# Bradfield to Behms Corridor Quality Assurance Report of DOT Roads to Resources Project

**Alaska Department of Transportation  
Roads to Resources Project  
LiDAR & Imagery  
Quality Assurance Report  
Bradfield to Behms Corridor**

**Written by Rick Guritz  
Alaska Satellite Facility  
July 24, 2015**

Figure 34, L31475\_15275 - Incorrect drawing name of L31465\_15275. This causes a loading conflict with tiles from adjacent data. Please correct drawing name.

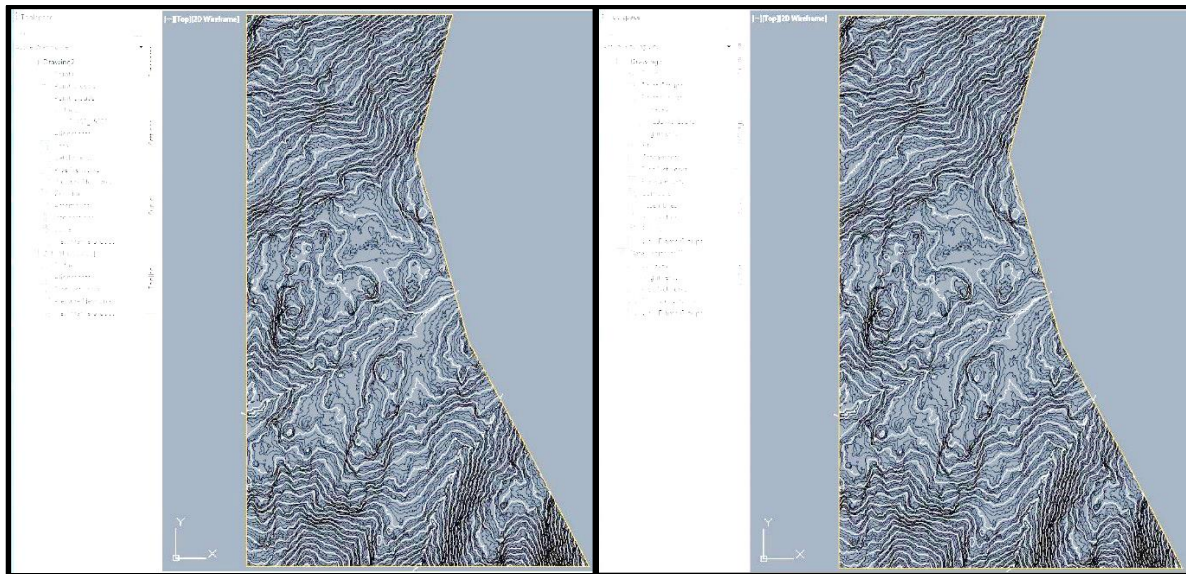
**UAF completed its initial review of Bradfield to Behms Corridor** – On 5/8/2015, UAF completed quality assurance review of Bradfield to Behms Corridor. Provided summary of data quality issues of concern: 1) First Return DSM: Tile Seams and Discontinuity issues in lower elevation areas of tiles: L31025\_15925 and L31050\_15925. The forested areas look good, not sure why this looks the way it does in the shaded relief image. Please explain. 2) Land XML: A) 15625 to 15675 - Not sure why the lake contours are so confused. Contour lines jump around and look bad. Is there anything that can be done to clean this up? B) L31050\_15875 - Tile includes a number of disconnected islands. Only four of these load any contour data. It looks like processing of this tile was interrupted and not finished processing. These islands should include contours to match up with adjacent tiles North and South (see Figure 32). C) L31050\_15925B - Island segment drawing name is incorrectly named L31050\_15925\_B which may cause confusion. This drawing name needs to be corrected (see Figure 33). D) L31425\_15375 - Bad tile edge, multiple drawing lines extending away from shore. Not sure what is going on here. Please clean up edge of data. E) L31475\_15275 - Incorrect drawing name of L31465\_15275. This causes a loading conflict with tiles from adjacent data. Please correct drawing name (see Figure 34).

**Tetra Tech responded** – On 2/7/2014, Renee provided initial responses to each data quality issue in a spreadsheet. Explained that seam in shaded relief is due to tidal changes that can't be fixed. Offered fixes for drawing name issues in LandXML tiles to be staged via ftp delivery.
